Type of Action: APD Change

Procedure Description: XTO respectfully requests approval to make the below listed changes to the approved APDs. 1. Casing design to be changed from the “4-String Design – Engineered Weak Point” (FIGURE F) to the “4-String Design – Open 1st INT x 2nd INT Annulus” (FIGURE D). An open annulus will be utilized and monitored during completions operations. Post completion, bradenhead squeeze will be performed to tie back the 1st intermediate x 2nd intermediate annulus. TOC will be placed into the 1st intermediate shoe but still below the base of Potash interval. 2. No changes to the cementing, casing or mud circulating system designs will be required for the requested change. 3. There is no new surface disturbance. Please refer to the R-111-Q well bore diagrams in the attachment reflecting the changes requested. WELL NAME API Number JRU Apache Federal Com 113H 30-015-55783 JRU Apache Federal Com 803H 30-015-55766 JRU Apache Federal Com 902H 30-015-55854 JRU Apache Federal Com 903H 30-015-55855 There is no new surface disturbance.

WELL NAME	API Number
JRU Apache Federal Com 113H	30-015-55783
JRU Apache Federal Com 803H	30-015-55766
JRU Apache Federal Com 902H

Previous Design: 4-String Design – Engineered Weak Point**[Figure F] 4 String – 2nd Intermediate casing engineered weak point**

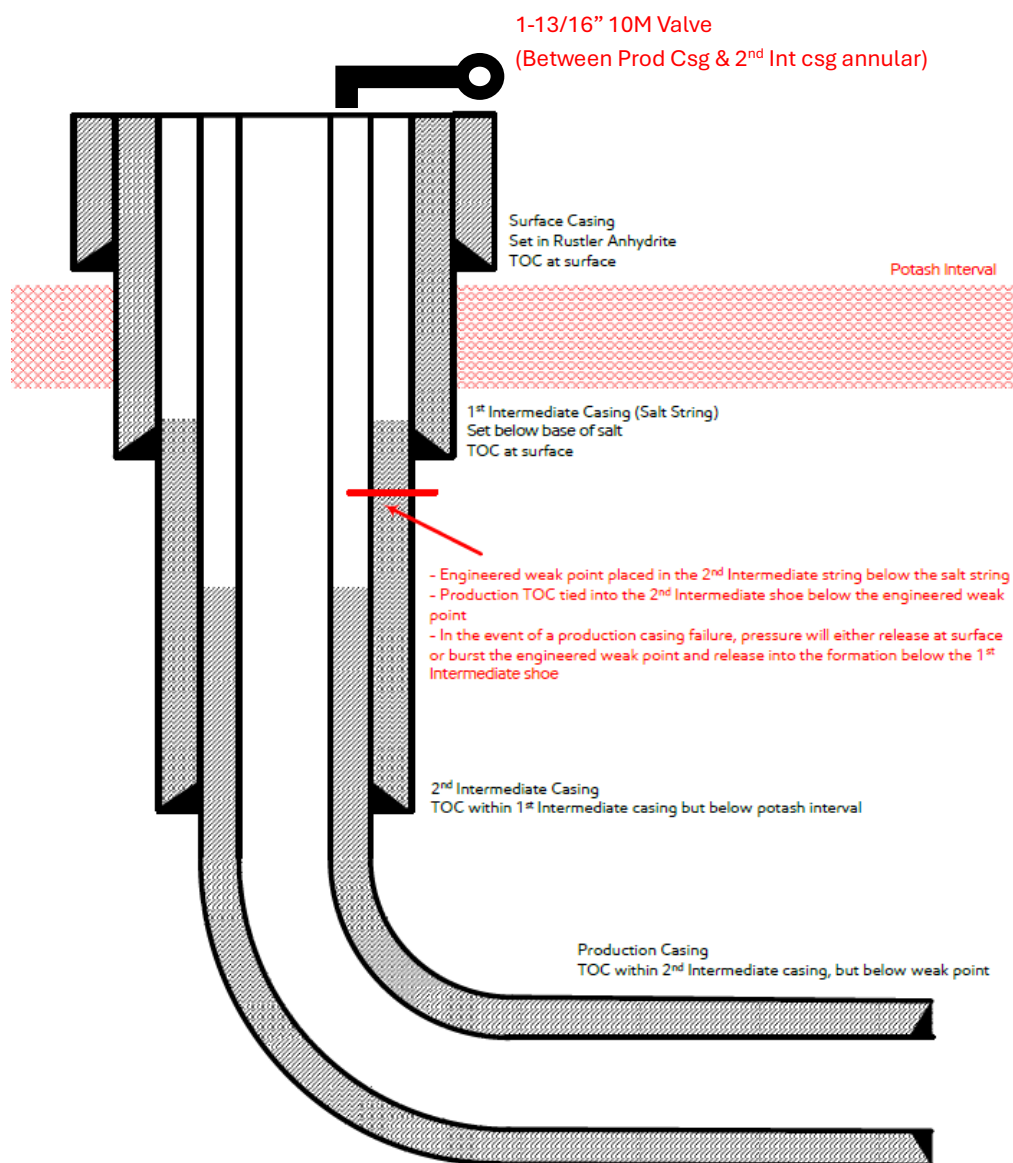
XTO respectfully requests approval to make the below listed changes to the approved APDs.

1. Casing design to be changed from the "4-String Design – Engineered Weak Point" (FIGURE F) to the "4-String Design – Open 1st INT x 2nd INT Annulus" (FIGURE D). An open annulus will be utilized and monitored during completions operations.

- 1) Alignment with KPLA requirements per schematic per schematic below, with engineering weak point casing design and utilizing new casing that meets API standards.
- 2) Contingency plans in place to divert fluids away from salt interval in event of production casing failure.
- 3) Intermediate 2 casing will consist of a primary cement job with TOC at the top of the Brushy Canyon formation within the Delaware Mountain Group.
 - a. Bradenhead squeeze to be completed after primary cement job to tie back TOC to intermediate 1 "Salt string" at least 500' but with top below Marker Bed 126 "Potash Interval".
- 4) Production cement to be tied back no less than 500' inside previous casing shoe (intermediate 2 casing) and below the engineered weak point.

[Figure D] 4 String – Uncemented annulus between 1st and 2nd intermediate casing strings

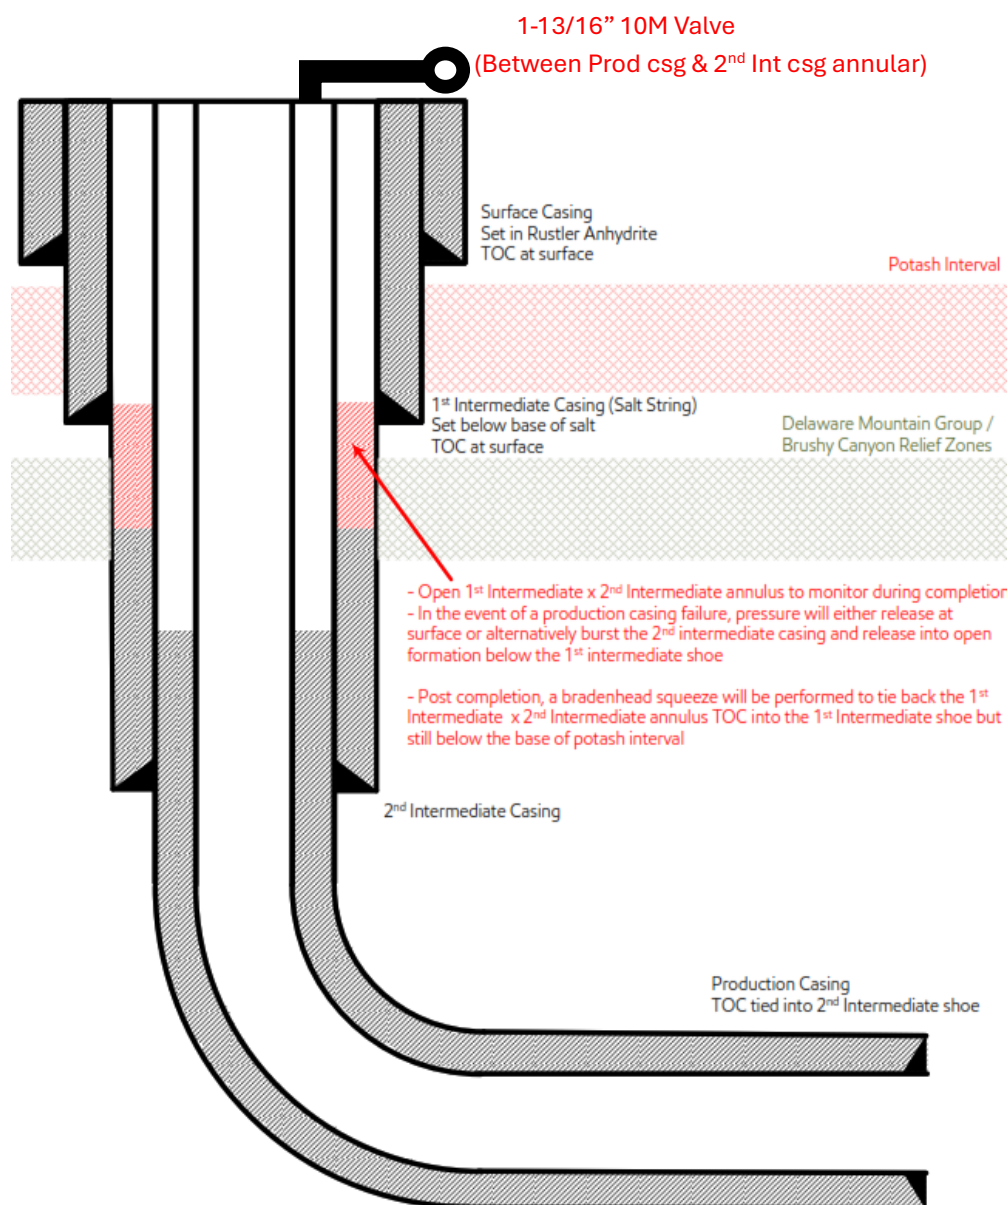
Post completion, bradenhead squeeze will be performed to tie back the 1st intermediate x 2nd intermediate annulus. TOC will be placed into the 1st intermediate shoe but still below the base of Potash interval.

New Proposed Design: 4 – String Design – Open 1st Int X 2nd Int Annulus (ICP 2 below relief zone)

- 1) Alignment with KPLA requirements per schematic above, leaving open annulus open for pressure monitoring during frac and utilizing new casing that meets API standards.
- 2) Contingency plans in place to divert fluids away from salt interval in event of production casing failure.
- 3) Intermediate 2 bradenhead squeeze to be completed within 180 days to tieback TOC to salt string at least 500ft but with top below Marker Bed 126.
- 4) Production cement to be tied back no less than 500ft inside previous casing shoe.
